Mobile Intel® Pentium® 4 Processor-M

Specification Update

December 2004

Document Number: **250721-028**

Figure 13. System Bus Reset and Configuration Timings

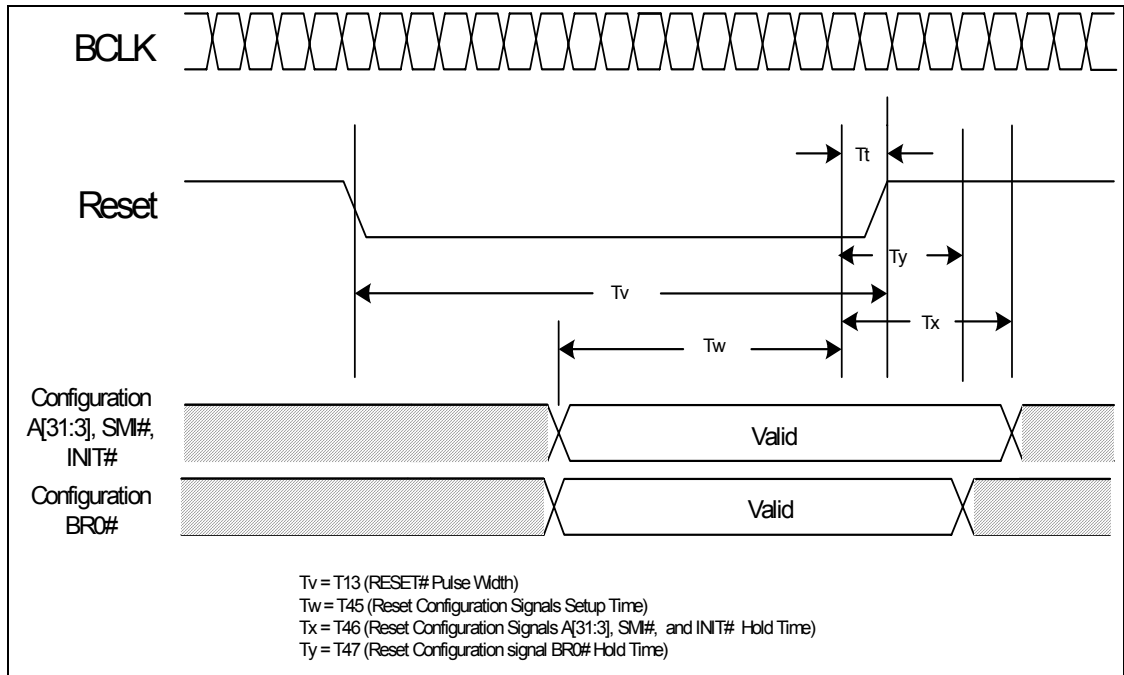
T2. BR0# Maximum Hold Time Specification Change

The BR0# maximum hold time has changed to 2 BCLKs. This change will be shown in the “System Bus AC Specifications (Reset Conditions)” table and “System Bus Reset and Configuration Timings” figure of the *Mobile Intel® Pentium® 4 Processor - M Datasheet*. This change will be incorporated in the next revision of the datasheet.

The following figure will be modified to reflect this change:

T# Parameter	Min	Max	Unit	Figure	Notes
T45: Reset Configuration Signals (A[31:3]#, BR0# INIT#, SMI#) Setup Time	4		BCLKs	13	1
T46: Reset Configuration Signals (A[31:3]#, INIT#, SMI#) Hold Time	2	20	BCLKs	13	2
T47: Reset Configuration Signal BR0# Hold Time	2	2	BCLKs	13	2
